Silver Snap-Tool

New version 7.57.43.56490

Here are the changes you will find in version 7.57.43.56490 of SSnT

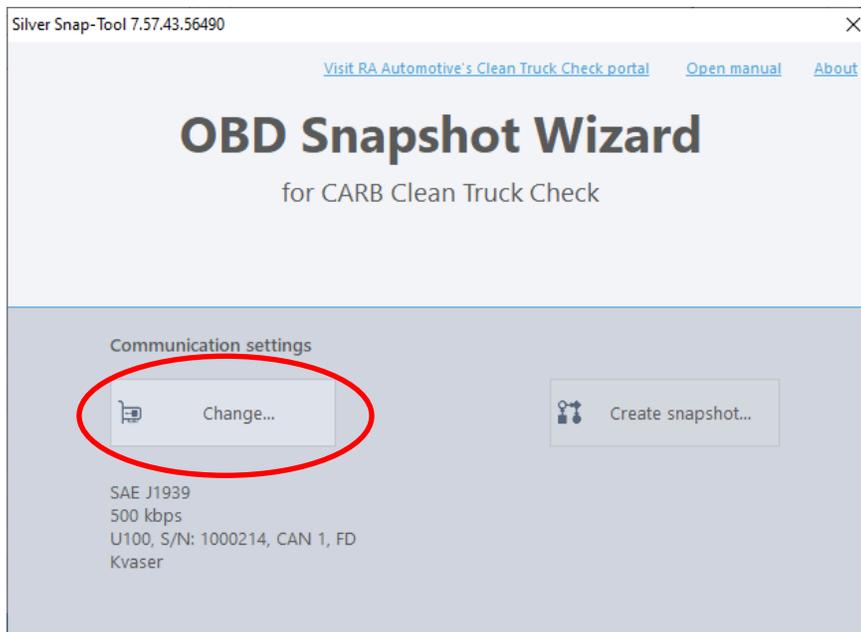
- The **start screen** now has only two buttons.
- There is no screen in the background.

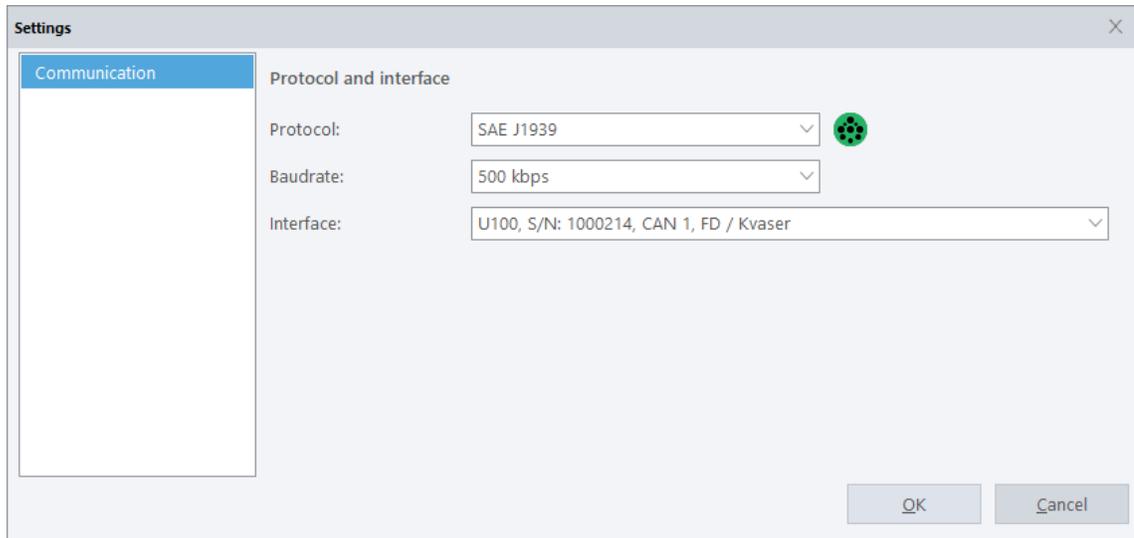
The **settings screen** is very similar to the previous version.

- Protocol selection, icon added to help make your selection more obvious.
- Interface selection, only the CARB approved devices can be selected here – assuming you have previously installed the corresponding drivers.

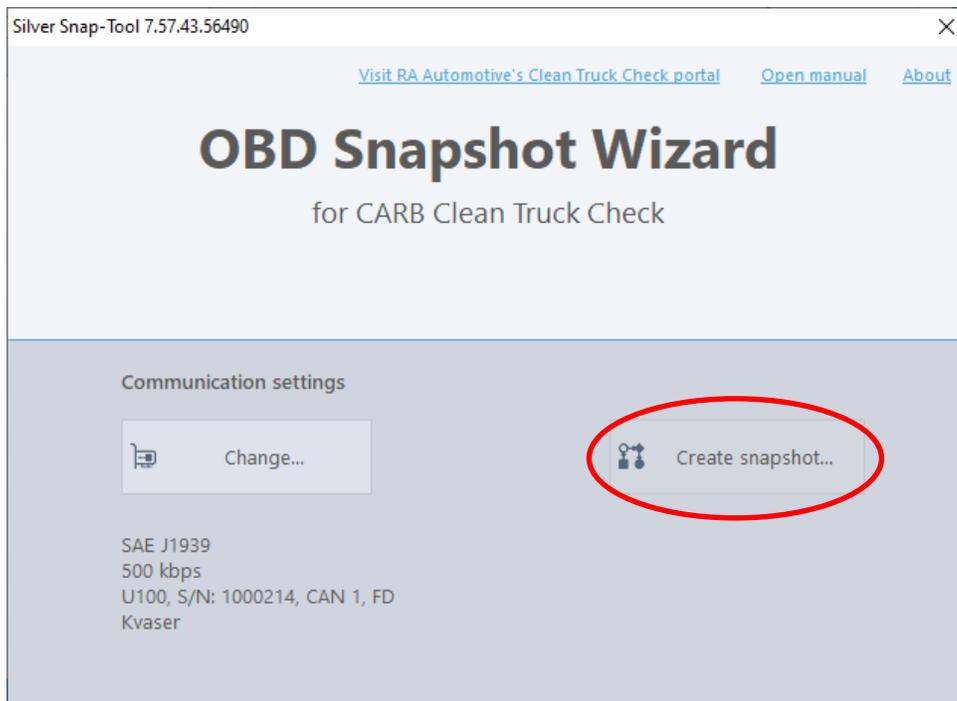
Tester will enter E-mail and their chosen Password, then click **Login**.

- Improved feature: a “peek” feature has been added to view your password before logging in.
- Improved feature: link added to reset password.

Note: In the new version, we have fulfilled a CARB requirement: You will automatically be logged out once the snapshot has been taken. You will need to log in again for each subsequent snapshot.
